SHINE MEDICAL TECHNOLOGIES, LLC OPERATING LICENSE APPLICATION RESPONSE TO REQUEST FOR ADDITIONAL INFORMATION AND SUPPLEMENT NO. 7

FINAL SAFETY ANALYSIS REPORT CHANGE SUMMARY PUBLIC VERSION

FINAL SAFETY ANALYSIS REPORT MARKUP

**Figure 4b.4-3 – Target Solution Preparation System Process Flow Diagram
(Sheet 1 of 2)**

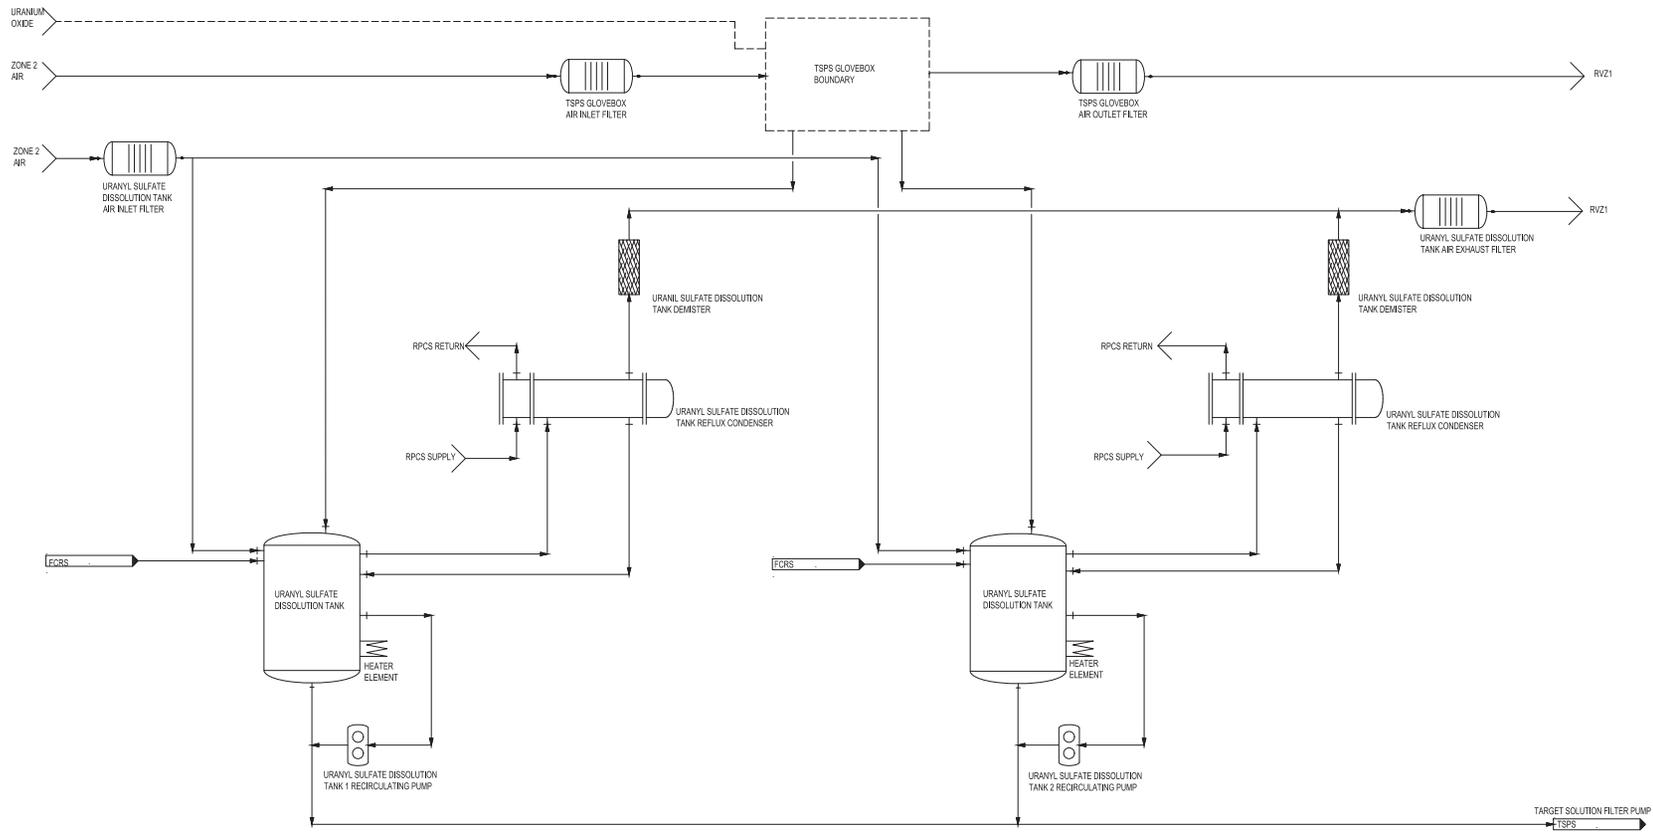
Summary Description of Changes	FSAR Impacts
Administrative corrections, including correction of inconsistencies, cross references, and typographical errors.	Table 2.4-7, Section 4a2.2, Section 9a2.1, Section 9b.7, Section 13b.1
Update to remove uranium concentration instrumentation in the radioactive liquid waste storage (RLWS) system.	Section 9b.7
Update to clarify byproduct material quantities associated with the molybdenum extraction and purification system (MEPS) and iodine and xenon purification and packaging (IXP) system.	Section 9b.5
Update to clarify that major target solution vessel (TSV) off-gas system (TOGS) components are made of austenitic stainless steel.	Section 4a2.8
Update to remove the light water pool liner leak chase and associated leak chase detection system.	Section 2.4, Section 4a2.4, Section 7.3, Section 13a2.1
Update to replace target solution preparation system (TSPS) uranyl sulfate dissolution tank mechanical agitators with recirculation lines to provide tank mixing.	Figure 4b.4-3, Section 6b.3

Figure 5a2.2-1 – Primary Closed Loop Cooling System Flow Diagram

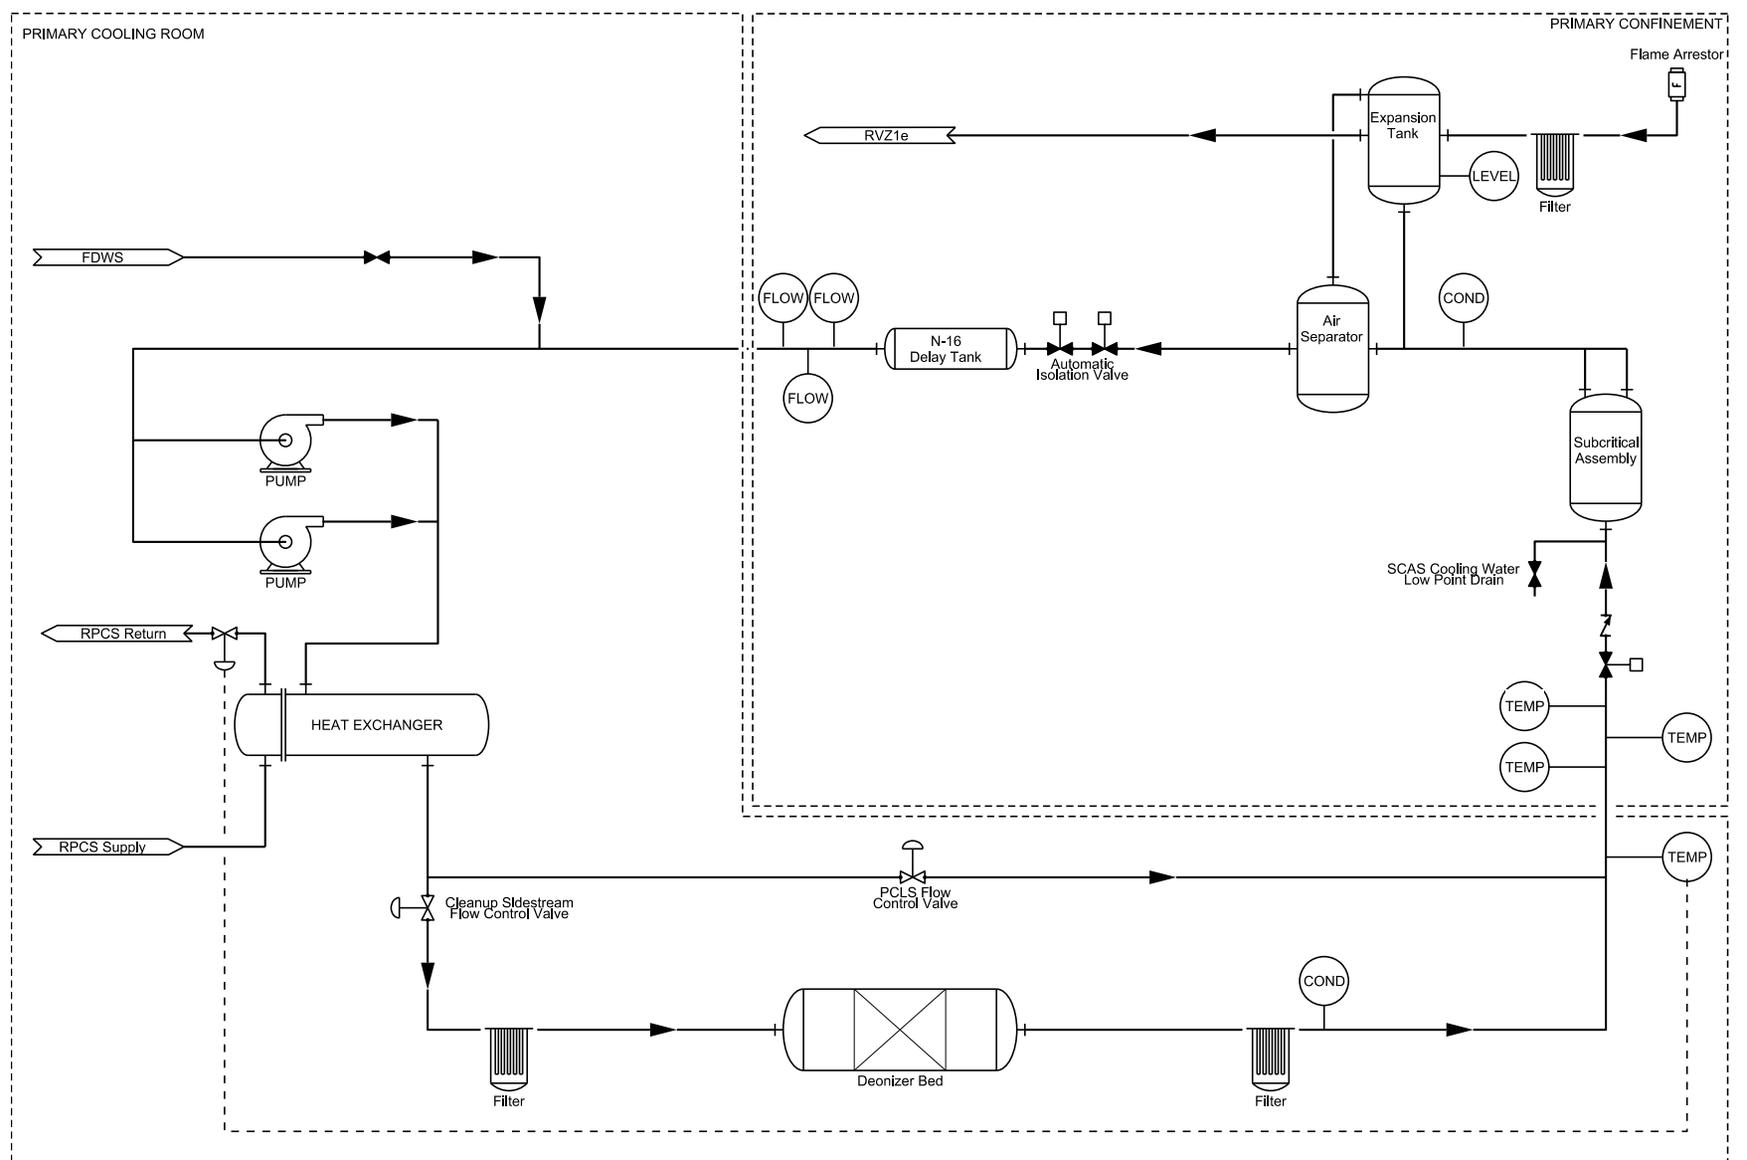
Update to the facility demineralized water system (FDWS) configuration to reflect design progression.	Section 5a2.6, Table 5a2.6-2, Figure 5a2.6-1
Update to PCLS configuration, including impacts associated with the deionizer bed and temperature element.	Figure 5a2.2-1, Section 5a2.5
Update to correct the instrument range and clarify the function of TPS tritium monitors.	Table 7.5-1, Section 9a2.7
Update to correct inconsistent RCA descriptions.	Section 1.2, Section 1.3, Figure 1.3-1, Section 4b.4, Table 4b.4-1, Section 9a2.5, Section 9b.5
Update to process integrated control system (PICS) functions related to supercell valve position indication to reflect available component functionality.	Section 7.3

Figure 9b.2-1 – Vacuum Transfer System Process Flow Diagram
(Sheet 6 of 6)

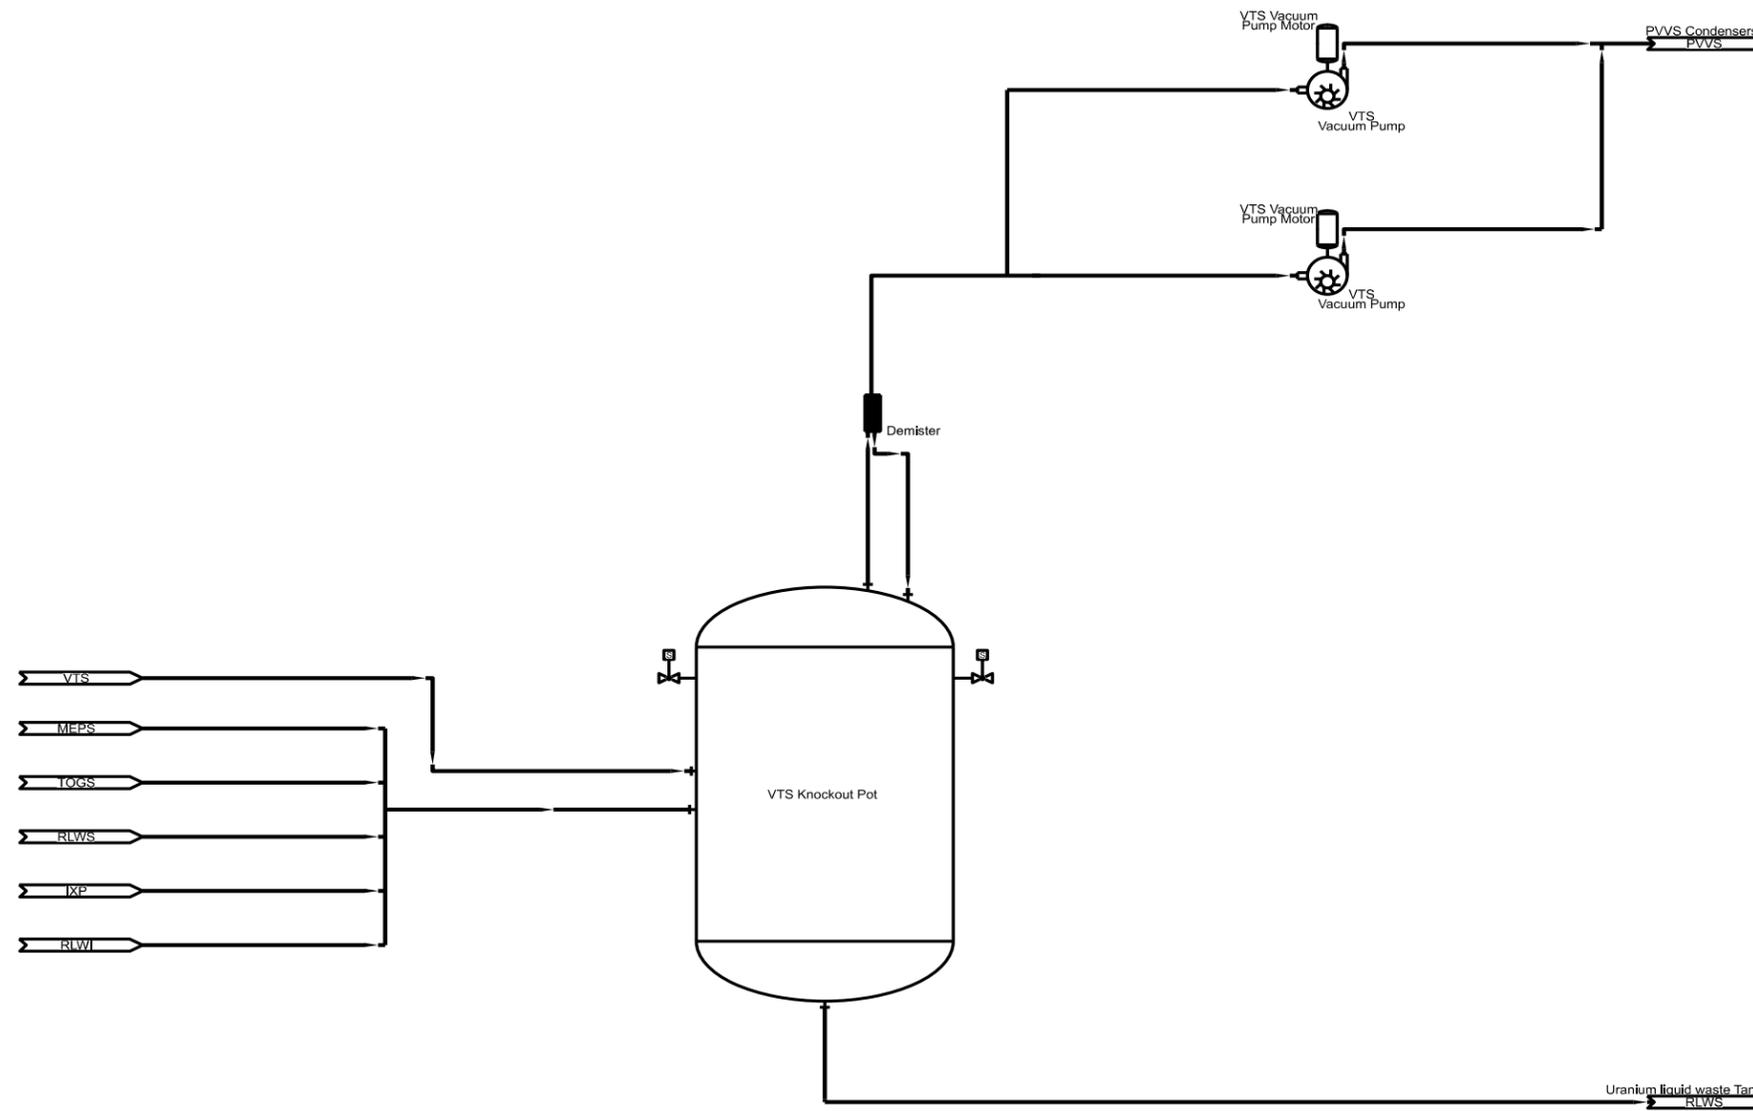
Update to replace vacuum transfer system (VTS) knockout pot vacuum relief valves with actuated valves, consistent with engineered safety features actuation system (ESFAS) described functions.	Figure 9b.2-1
Update to correct facility nitrogen handling system (FNHS) interfaces with TSPS, primary closed loop cooling system (PCLS), target solution storage system (TSSS), quality control and analytical testing laboratories (LABS), IXP, VTS, radioactive drain system (RDS), and production facility biological shield (PFBS).	Table 4b.4-3, Table 5a2.2-3, Table 9b.5-1, Section 9b.7, Table 9b.7-4, Table 9b.7-5
Update to incorporate MEPS pneumatically driven pumps.	Table 4b.3-1, Section 9b.7, Table 9b.7-5, Figure 9b.7-6
Update to the arrangement drawing to reflect configuration changes (e.g., door between battery rooms and uninterruptible power supply system [UPSS] rooms, electrical equipment room door, and removal of radiologically controlled area [RCA] designation).	Figure 1.3-1
